BERMUDA INTEGRATED RESOURCE PLAN 2024

CONSULTATION RESPONSE COMMISSIONED BY BE SOLAR

October 2024

EV load shapes assumed in BELCo’s Integrated Resource Plan, based on U.S. Department of Energy Alternative Fuel Data Centre model for Kahului. © Charles Rivers Associates

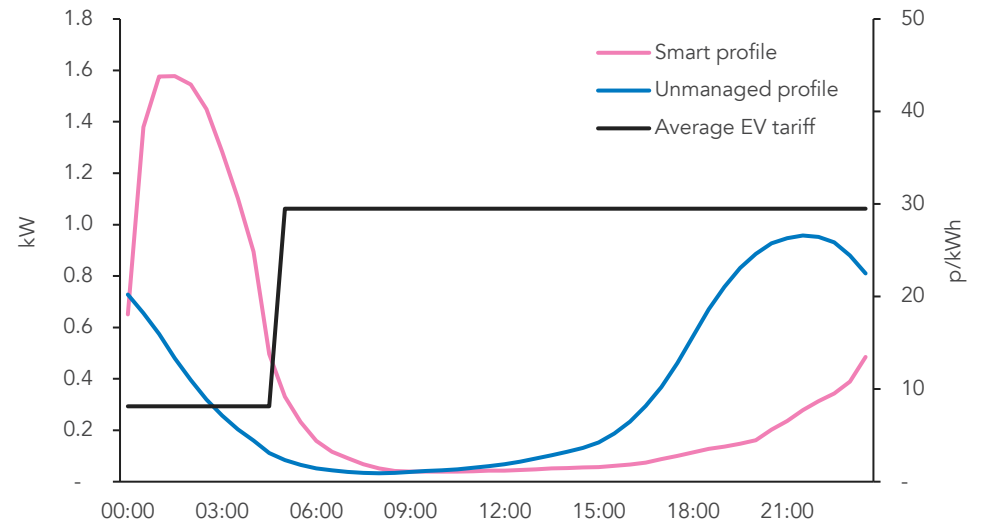
The upper adjacent graph shows the electric vehicle load profiles assumed in the IRP, while the lower graph shows the profiles assumed by the UK National Grid. The unmanaged (blue) profiles are similar in both magnitude of load and timing of load over a 24 hour period.

The smart profiles assumed in the National Grid modelling have been developed in conjunction with ev.energy, who we understand develop profiles based on models that combine their data on time of use pricing with charging behaviours. This produces realistic charging profiles for use in energy scenario planning.

- Model at least one portfolio with smart charging
- Model at least one portfolio with bidirectional charging
- Quantify potential reduction in cost from smart and bidirectional charging, and whether it would allow for cost-effective integration of more offshore wind and solar.

Levelised costs of energy calculated in the IRP Assessment Report were generally higher for renewables and lower for LNG than those calculated in BELCo's IRP and the Bermuda Better Energy Plan. A set of assumptions that is favourable to LNG appear to have been used. © Ricardo.

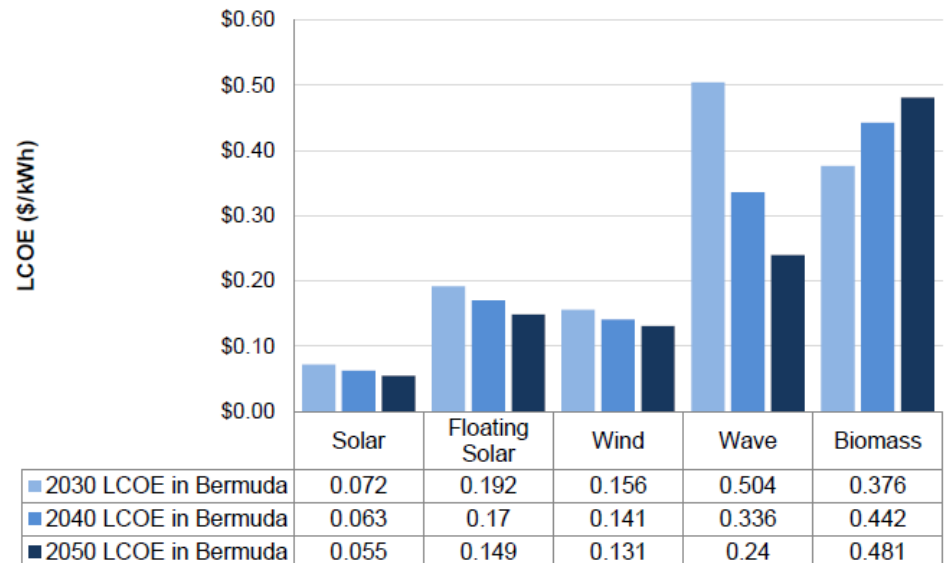
- The LCOE's indicated in the report are higher than those in BELCo's IRP. This appears to be due to the use of a 10% discount rate, which increases the cost for offshore wind and solar. No justification is provided for the higher discount rate. Reasons why we do not believe this is a sensible assumption include BELCo's cost of debt being around 8%, BVG Associates specifically recommending a 7.5% rate when calculating the LCOE for offshore wind in Bermuda, and local banks offering both mortgages and green loans for solar at 6.5% - 6.75%.

- We have low confidence in the LCOE figures calculated by the report as the assumptions used to calculate them are not provided. Spot checks indicate the figures for offshore wind appear to be high and use of a single figure for onshore solar may be overly simplistic given significant differences in cost between different types of system. LNG figures will depend heavily on infrastructure costs, which are not provided.

Compound annual electricity growth rates calculated in the IRP Assessment Report using an undeclared set of assumptions. It is unclear if these are directly comparable with the values in BELCo’s IRP © Ricardo.

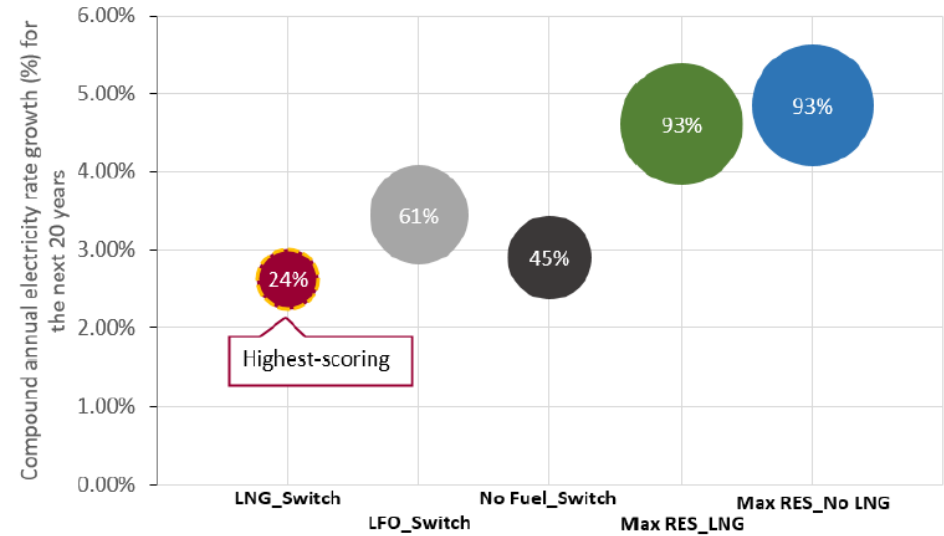
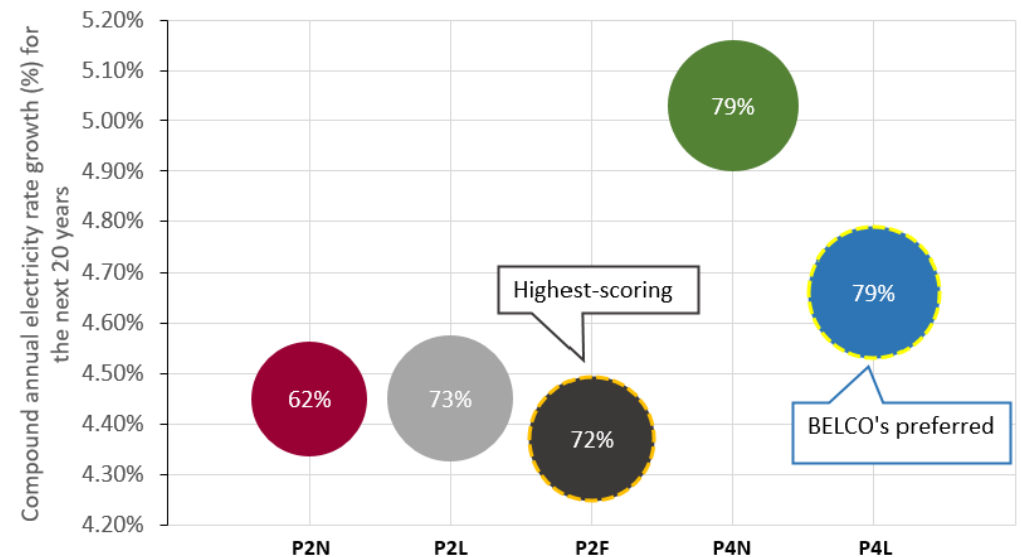
- We were unsurprised that the LNG_Switch scenario was preferred based on the set of assumptions, indicators, and weightings used in the analysis. However, we do not consider this finding to be reliable and are confident that re-running the analysis with a more developed and realistic set of assumptions would identify lower cost portfolio options that retain light fuel oil while deploying large amounts of offshore wind, solar, and battery storage.

- The compound annual growth rate of 2.6% for the LNG_Switch scenario is much lower than the value calculated in BELCo’s IRP, however the reasons for this are unclear as the report claims similar LNG fuel price assumptions were used. This implies that capital costs for engine conversions and the regasification terminal may have been reduced. These are important assumptions that should be provided if the analysis is to be considered credible.

- A 31% reduction in emissions cannot occur in the LNG_Switch scenario if lifecycle emissions are included. In any case, even a 31% reduction would not be compliant with an IPCC C1 1.5°C pathway, and could not therefore be considered ‘environmentally sustainable’ for the purposes of the Electricity Act or National Fuel Sector Policy.
